Reach Stepwell Brackets Service Bulletin

Customer: FedEx Express

Situation: Mount brackets may deform or crack on right-hand stepwell intermediate step.

Corrective Action Summary: Replace brackets

Score bracket and remove rivets

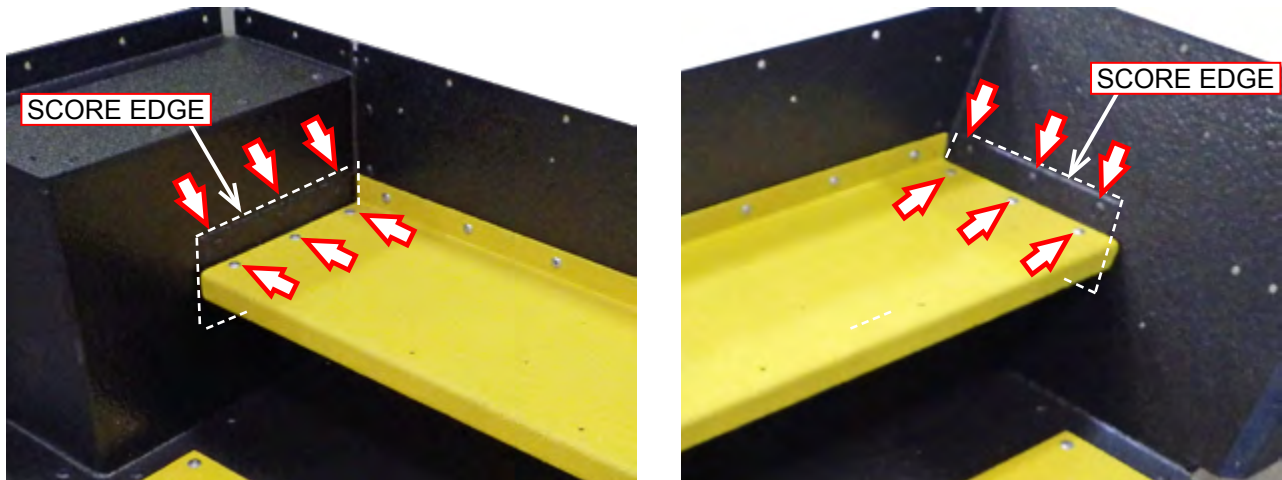
The mid step does **NOT** need to be removed to replace brackets.

1. Use a utility knife to score the coating around front and rear brackets.
2. Use a center punch to knock out the stem of (12) rivets.

3. Use an F (or 1/4") bit to drill off the head of the (6) blind rivets on the mid step. Remove (6) rivets attaching the rear and front brackets to the stepwell panels.

4. Remove and discard brackets.
5. Use existing holes and 1/4" rivets to secure replacement brackets.
